TECHNICAL MEMORANDUM

To: Randy Dorman, Brookfield
From: Kleinschmidt
Date: September 15, 2021
Re: **Review of MDMR's Comments and NLF Conceptual Designs Filed with FERC for the Shawmut Project (P-2322)**

Figure 1. NLF Map.

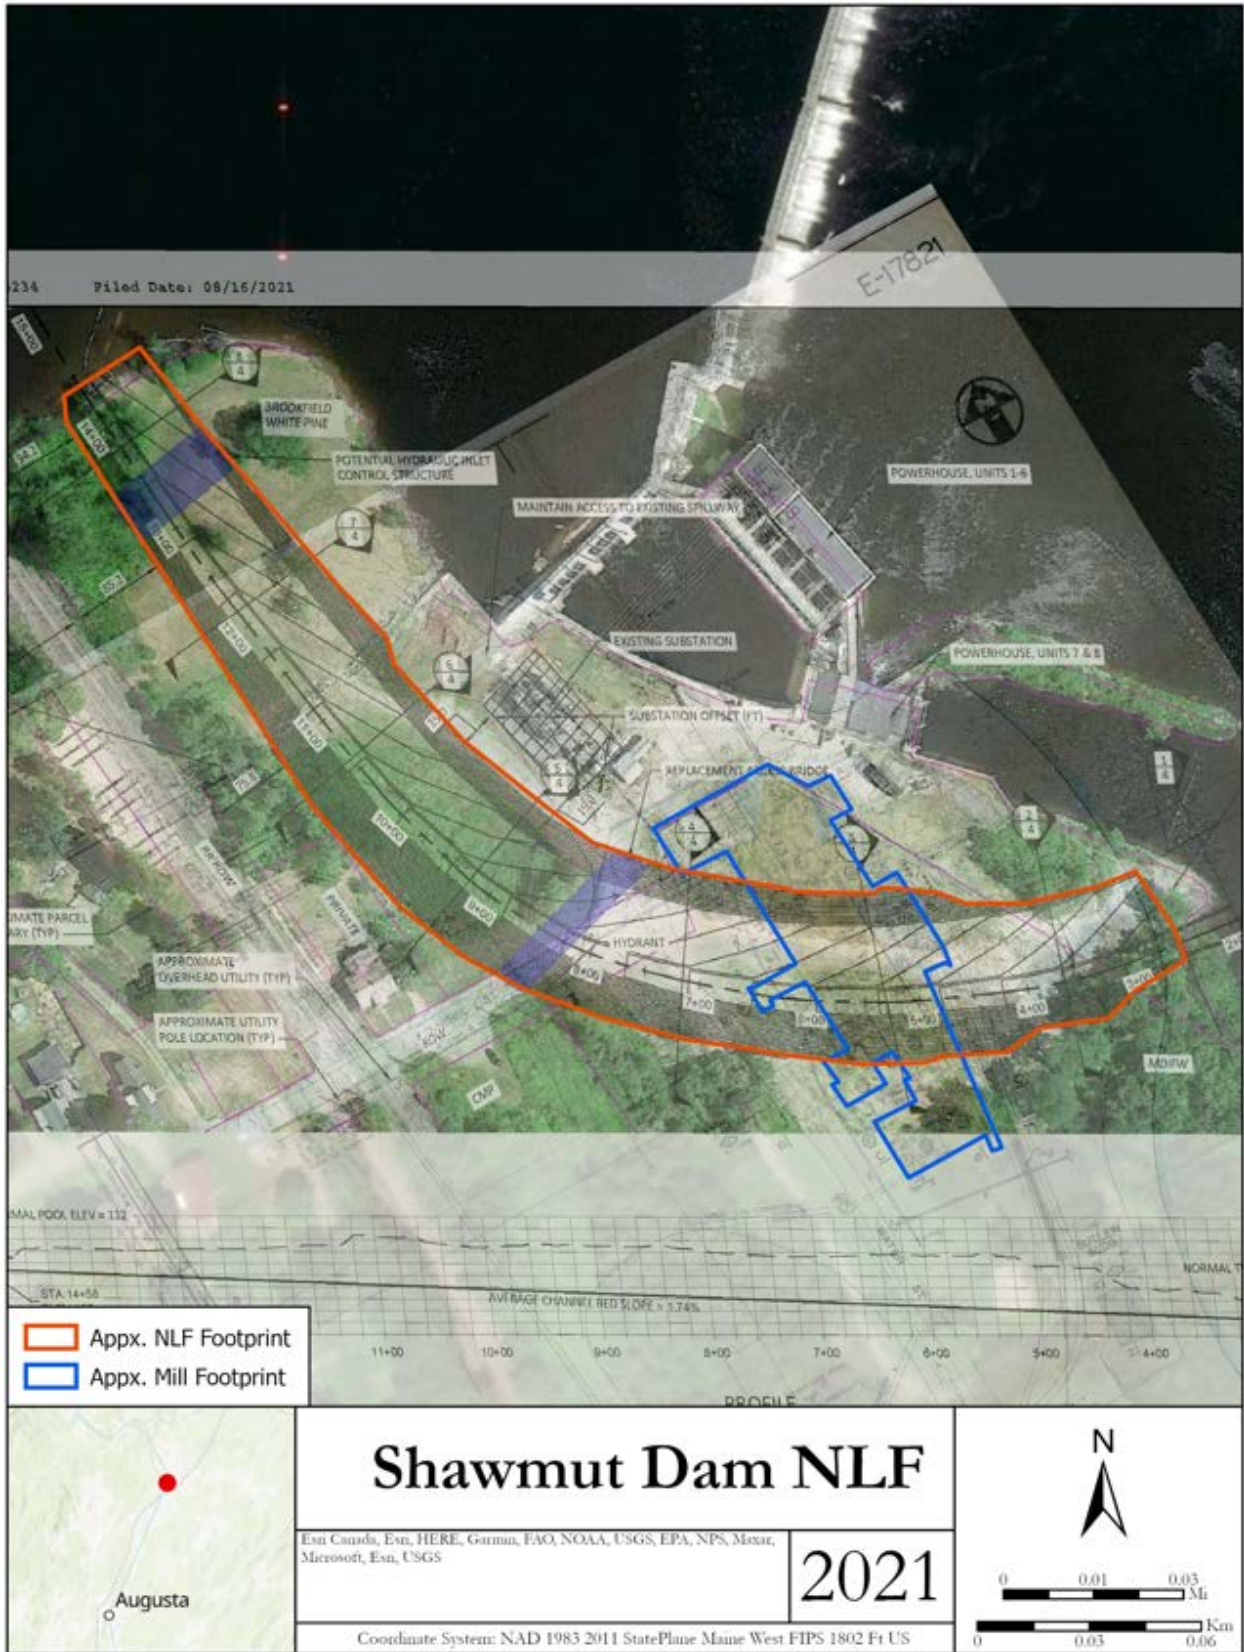
Both NLF concepts will run through the site of the former China Groundwood (previously Keyes Fibre) mill (Figure 1). Concept design information acknowledged the potential presence of unknown material and indicated potential contaminated soil issues. However, no assessment of the impacts of the presence of legacy structures or historic contamination has been conducted. According to Brookfield operations personnel familiar with the mill demolition, remnant infrastructure (e.g., sewer and drainage) remains

buried at the site. None of these factors nor how they could be addressed are analyzed in the MDMR NLF conceptual design materials. Encountering such issues can add considerable delay, cost, and uncertainty to construction. A thorough assessment of potential legacy contamination at an historic industrial site is critical to evaluating the feasibility of the MDMR NLF designs.
